South Carolina Electric & Gas Company
Virgil C. Summer Nuclear Station (VCSNS) Units 2 and 3

NND-14-0XYZ

License Amendment Request:
Auxiliary Building Structural Floor and Roof Details
(LAR 14-01)

Proposed Changes to Licensing Basis Documents
(LAR 14-01)

UFSAR Chapter 3, Appendix 3H, Figure 3H.5-6, [*Auxiliary Building Typical Composite Floor*]* - Revise Tier 2* information as shown in the figures following this page. A separate sheet displaying the notes proposed to be added to this figure is provided to aid in review of the proposed changes.

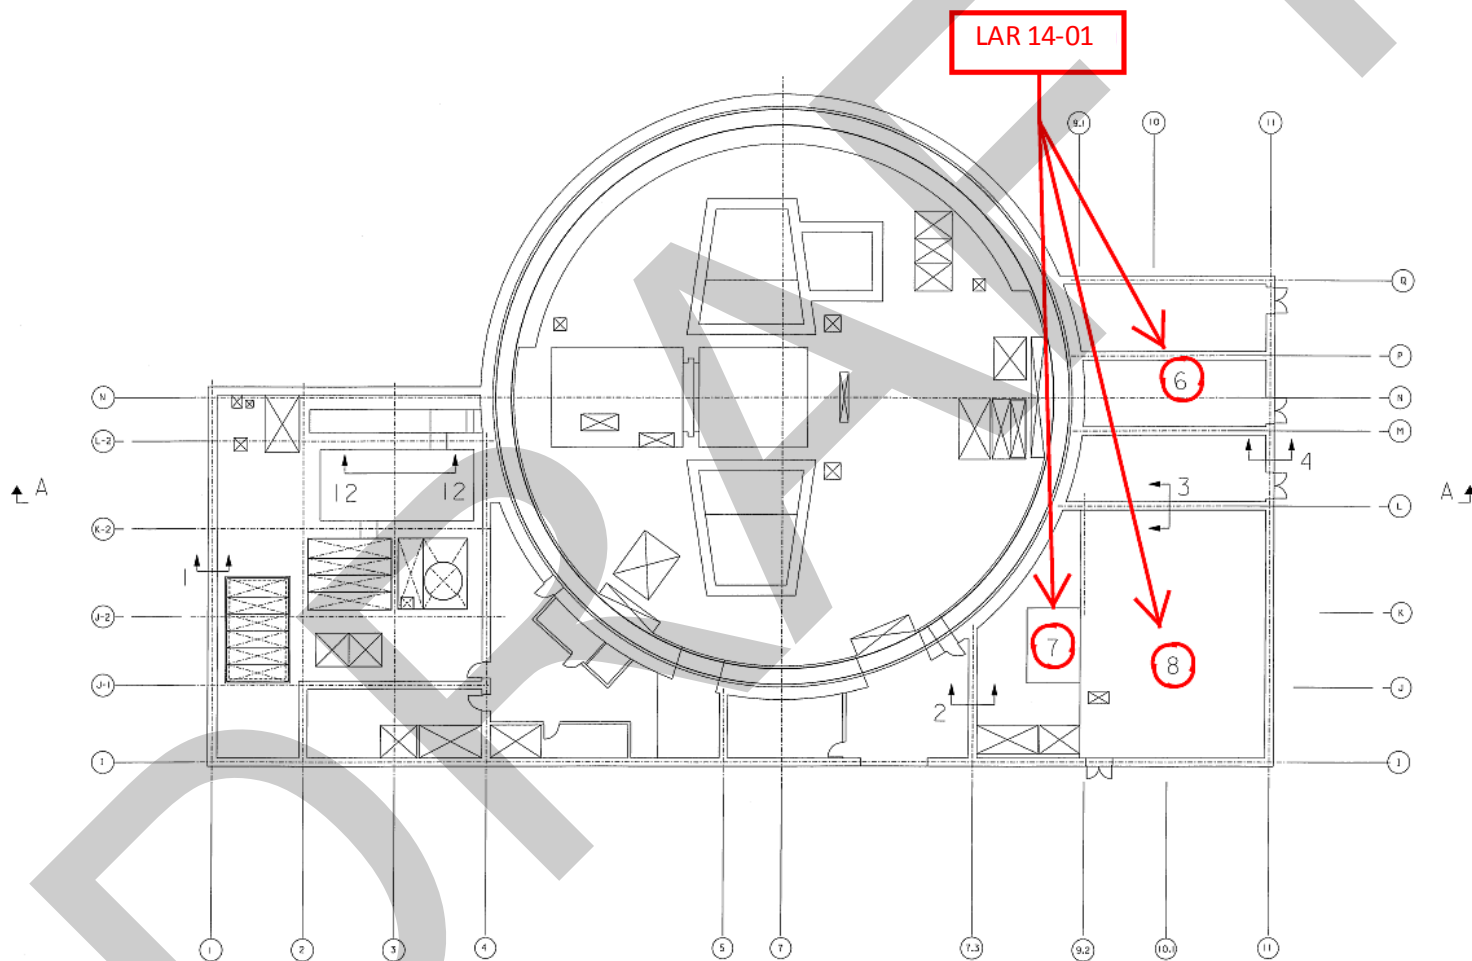
The beam supports and panel supports are shown with deformed wire anchors embedded in the concrete in the revised figures. The deformed wire anchors are used at the critical section as well as other floor sections. The embedment design satisfies the requirements of ACI 349 Appendix B and other sections of ACI 349 as required by Appendix B for deformed wire anchors. The number and spacing of the anchors can be different than that shown in the figure based on local loads. Headed shear studs can be used in lieu of deformed wire anchors. The design of the portion of the support exterior

to the wall satisfies AISC N690 requirements. Gussets and supporting plates can have a different size or shape based on the local loading condition and orientation between the beam and wall. Additional plates or structural shapes not shown in the figure can be used. In some locations the beam and panel supports are connected to a structural wall module.

Notes proposed to be added to Figure 3H.5-6:

- 1) Detail shown is specific to the composite floor at El. 135' -3" at intersection with Wall M. Refer to Subsection 3H.5.2 and other notes for additional information about design details for other floor sections.

- 2) [Previous Note 1 renumbered to Note 2.]
- 3) Floor beam size and spacing are designed based on floor load and geometry to satisfy AISC N690 requirements. The beam sizes used are predominately W14x26 and W14x48. The range of beam sizes is from W10 to W44. The spacing between the beams is predominately in a range of 5 to 6 feet.

- 4) The reinforcement shown is for locations away from openings, penetrations, embedments, and other obstructions.
- 5) Reinforcement size and spacing are based on the requirements in ACI 349 for flexural reinforcement.

- 6) The adjacent wall may be designed as a structural wall module.
- 7) The detail design, location and embedment of the beam supports are designed to the requirements of AISC N690 and ACI 349 as applicable. Support configuration, including the use of plates, structural shapes, and stiffeners, is based on loading and local geometry considerations. The design of embedment anchorage including type, size, and spacing satisfies the requirements of Appendix B as well as other applicable sections of ACI 349.

UFSAR Figure 3H.5-1 (Sheet 1 of 3) markups

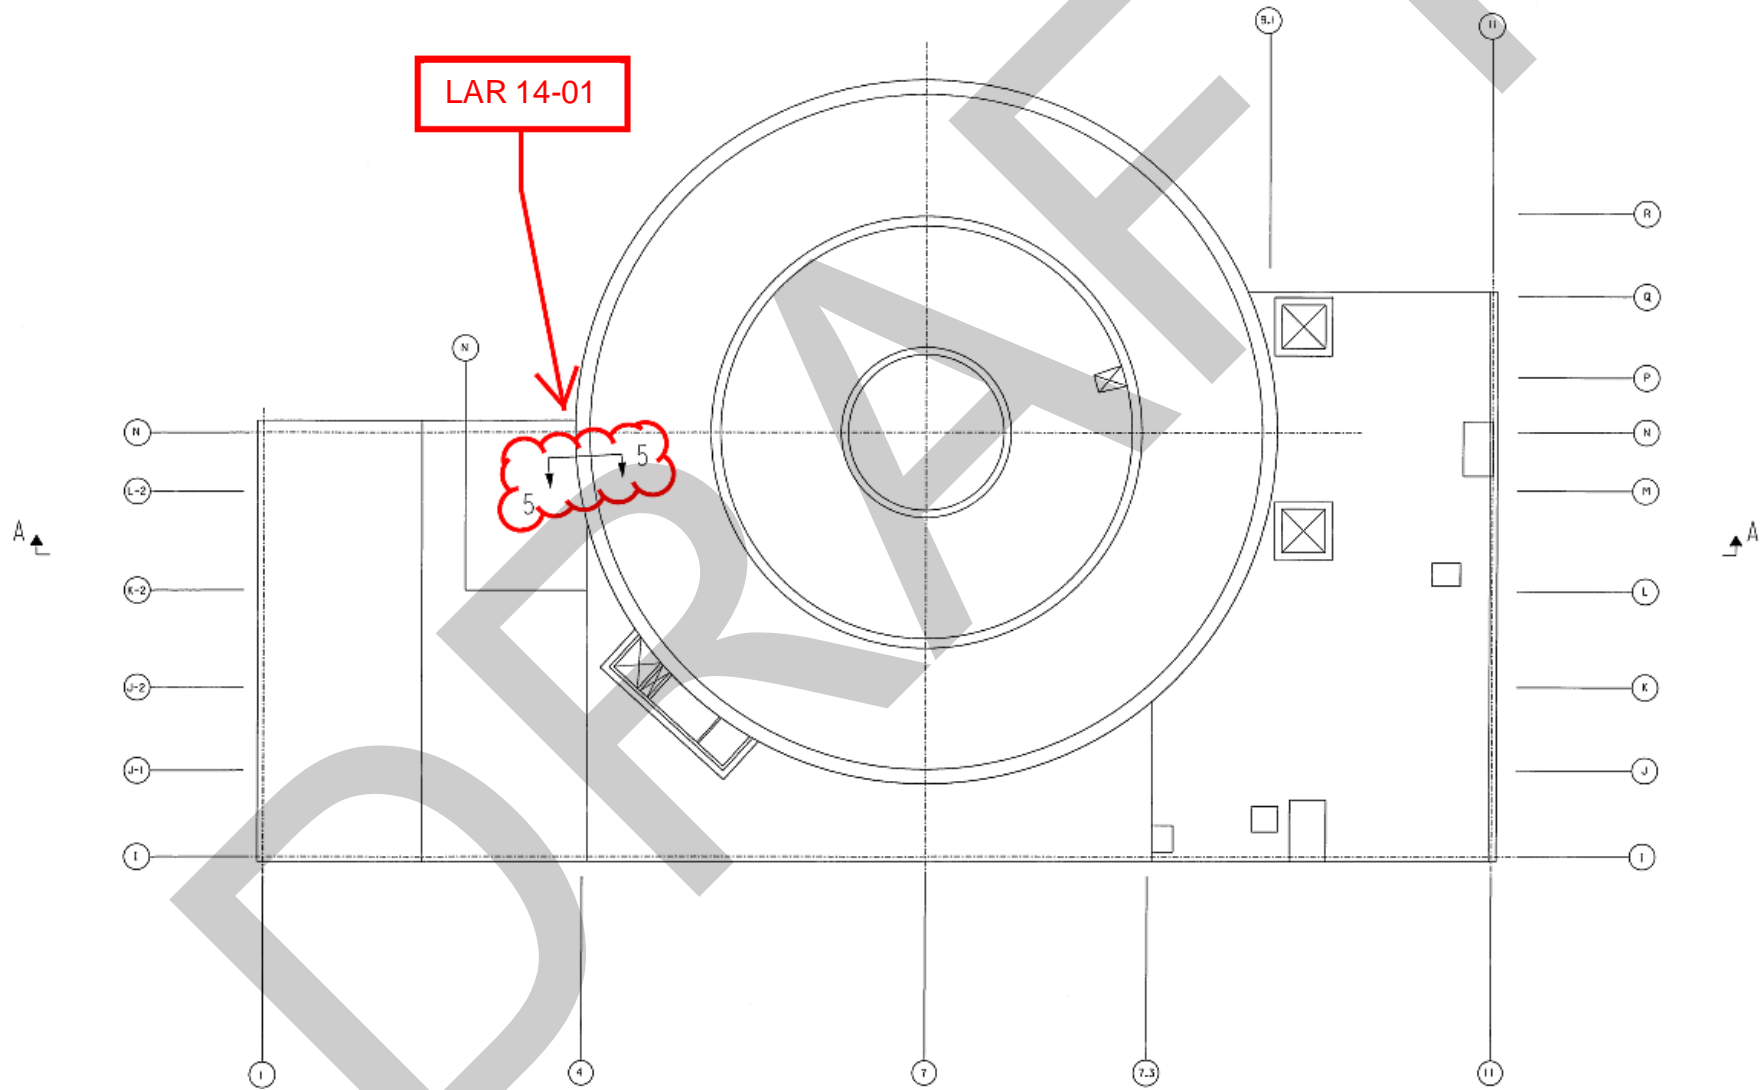
The change to Figure 3H.5-1 is an administrative change so that the labels on the figure conform to the Item numbers in the list in UFSAR Subsection 3H.5-1. This change does

UFSAR Chapter 3, Appendix 3H, Figure 3H.5-1 (Sheet 1 of 3), [*Nuclear Island Critical Sections Plan at El. 135'-3"*]* - Revise critical section indications to better match Subsection 3H.5.

UFSAR Figure 3H.5-8 markups

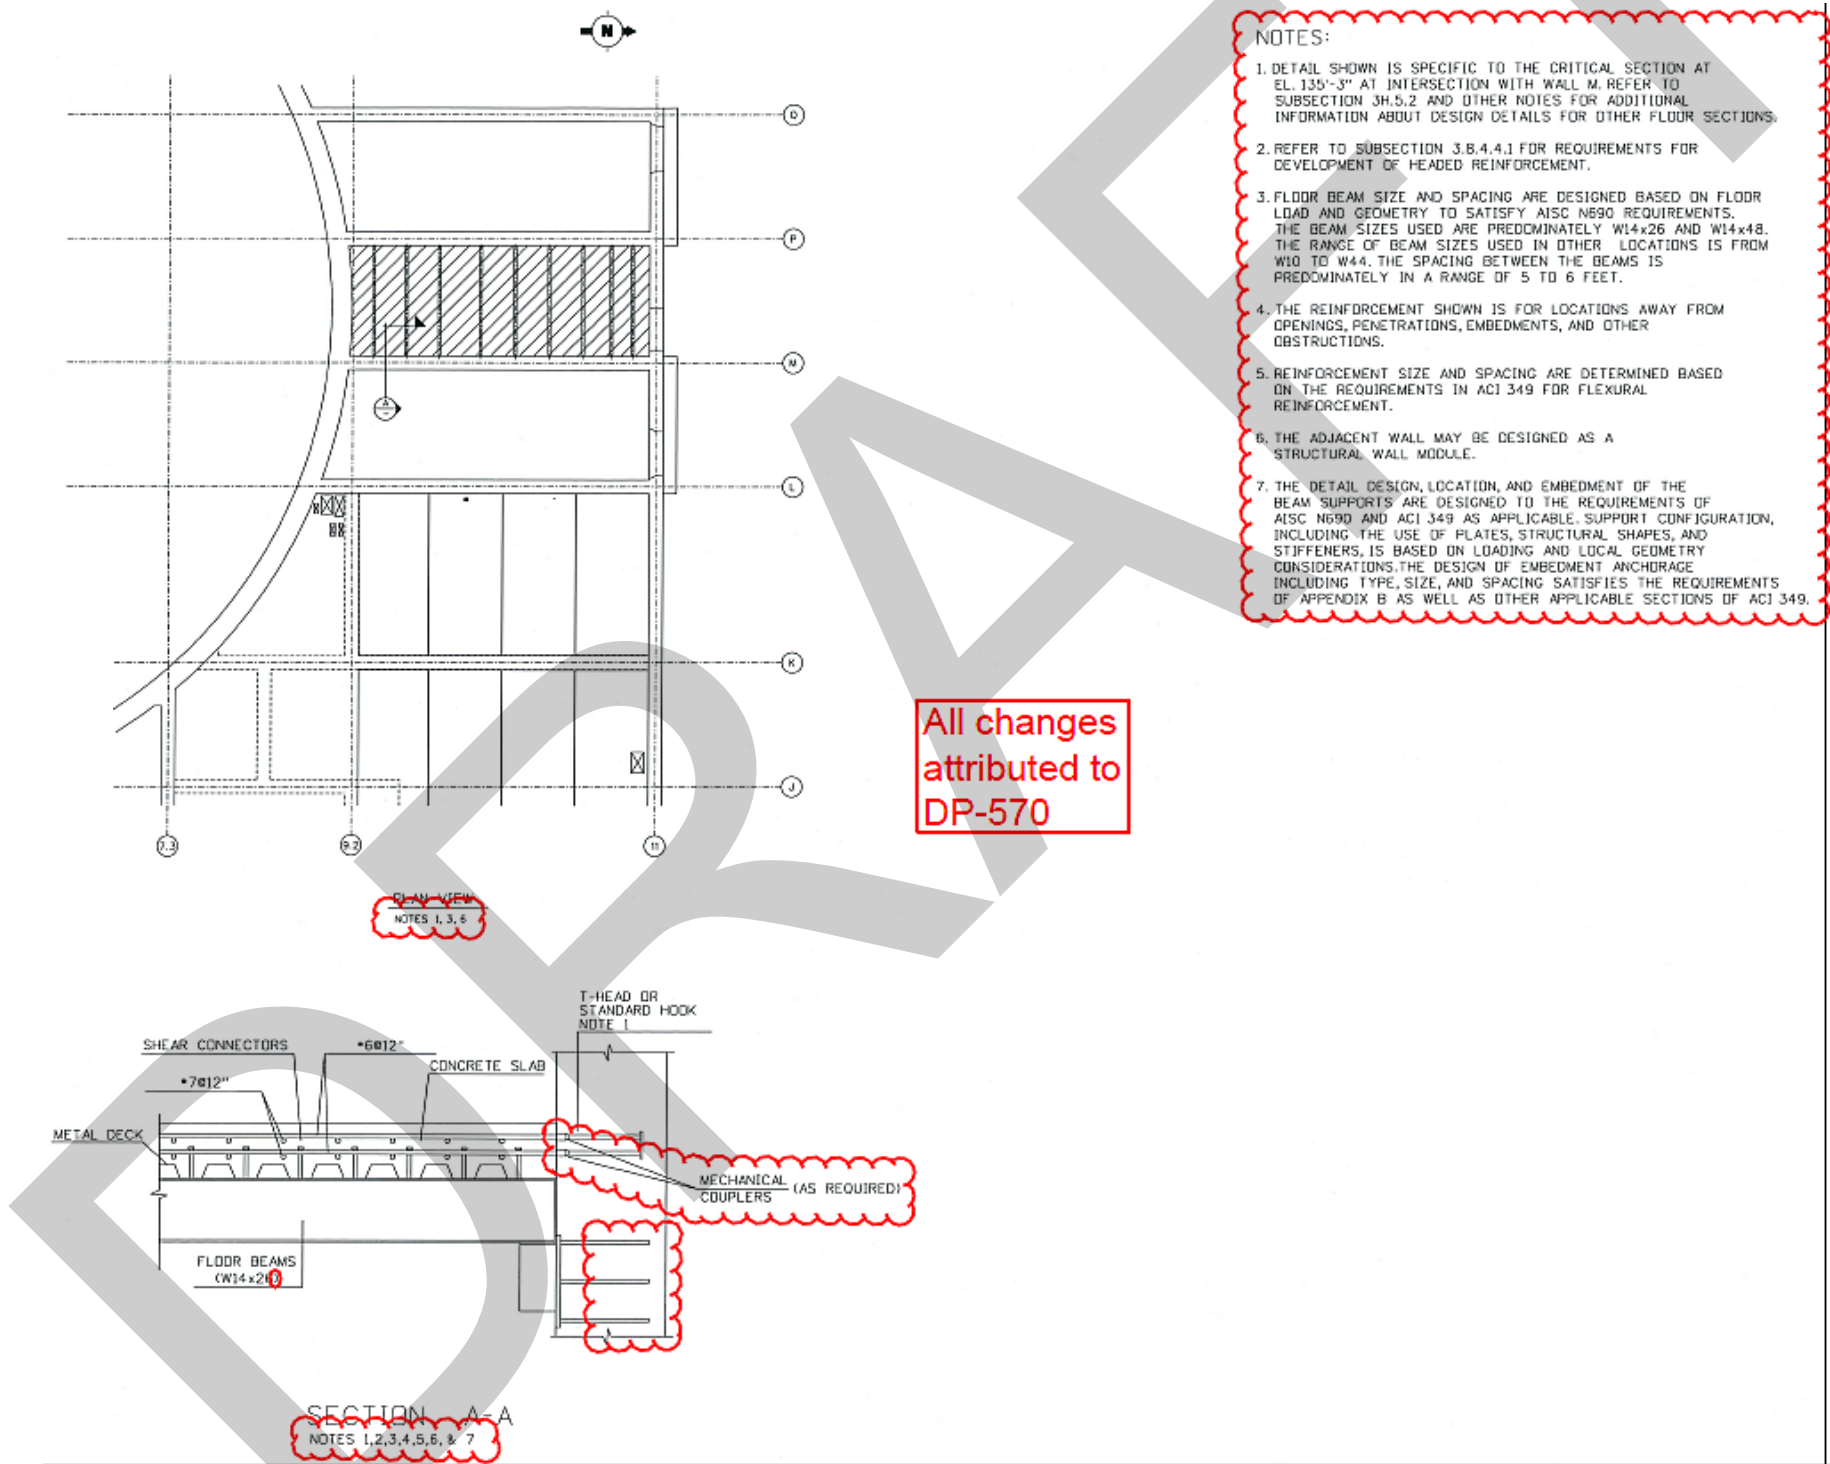
The proposed changes include implementation of requirements for development of headed reinforcement. These changes include, changing the term “Anchor Plates” to “T-Heads”, extending the lengths of the reinforcement into the walls, and adding a note to the drawing identifying the requirements for development of headed reinforcement on Figure 3H.5-8. These requirements are based on requirements in ACI 318-11, Section 12.6. The use of these requirements was approved in a previous license amendment and incorporated into Subsections 3.8.3.5, 3.8.4.4.1, and 3.8.4.5.1 of the licensing basis. See SCE&G COL Amendments 2 and 5 (Adams Accession Numbers ML13056A183 and ML13149A314, respectively).

The proposed changes to the reinforcement in UFSAR Figure 3H.5-8 are incorporated to provide reinforcement in the cast-in-place concrete consistent with the analysis to resist the loads in the cast-in-place concrete without relying on the flexural reinforcement in the precast panels. The figure is also revised to make a minor change to be consistent with drawing convention. The revised design is in conformance with ACI 349. The drafting convention changes do not change design information or design requirements. The proposed changes to the detail design of the auxiliary building floors do not change the function, design, or operation of the systems and components supported by the floors in the auxiliary building. The proposed changes do not change the function, design, or operation of the containment vessel and passive containment cooling system. The proposed changes do not affect the prevention and mitigation of abnormal events, e.g., accidents, anticipated operational occurrences, earthquakes, floods and turbine missiles, or their safety or design analyses. The proposed changes do not involve, nor interface with, any structure, system or component accident initiator or initiating sequence of events, and thus, the probabilities of the accidents evaluated in the UFSAR are not affected.

UFSAR Chapter 3, Appendix 3H, Figure 3H.5-8, [*Auxiliary Building Operations Work Area (Tagging Room) Ceiling*]* - Revise Tier 2* information as shown in the figures following this page. A separate sheet displaying the notes proposed to be added to this figure is provided to aid in review of the proposed changes.

Notes proposed to be added to Figure 3H.5-8:

- 1) Detail shown is specific to the reinforced concrete floor at El. 135'-3" (operations work area ceiling). Refer to Subsection 3H.5.3 and other notes for additional information about design details for other floor sections.

- 2) Refer to Subsection 3.8.4.4.1 for the requirements for development of headed reinforcement.
- 3) The precast panel thicknesses are nominally 8, 10, and 12 inches.

- 4) The overall floor thicknesses are nominally 24 and 36 inches
- 5) The thicknesses of the cast-in-place concrete are nominally 14, 16, 24, and 28 inches.

- 6) Reinforcement size and spacing for the precast panel are based on the requirements in ACI 349 for flexural reinforcement.
- 7) The reinforcement shown is for locations away from openings, penetrations, embedments, and other obstructions.

- 8) Reinforcement size and spacing in the cast-in-place concrete are based on the requirements in ACI 349 for flexural reinforcement.
- 9) The size and spacing of the shear stirrups satisfy ACI 349 reinforcement requirements for in plane shear and to provide for composite action.

- 10) The detail design, location, and embedment of the panel supports are designed to the requirements of AISC N690 and ACI 349 as applicable. Support configuration, including the use of plates, structural shapes, and stiffeners, is based on loading and local geometry considerations. The design of embedment anchorage, including type, size, and spacing satisfies the requirements of Appendix B as well as other applicable sections of ACI 349.
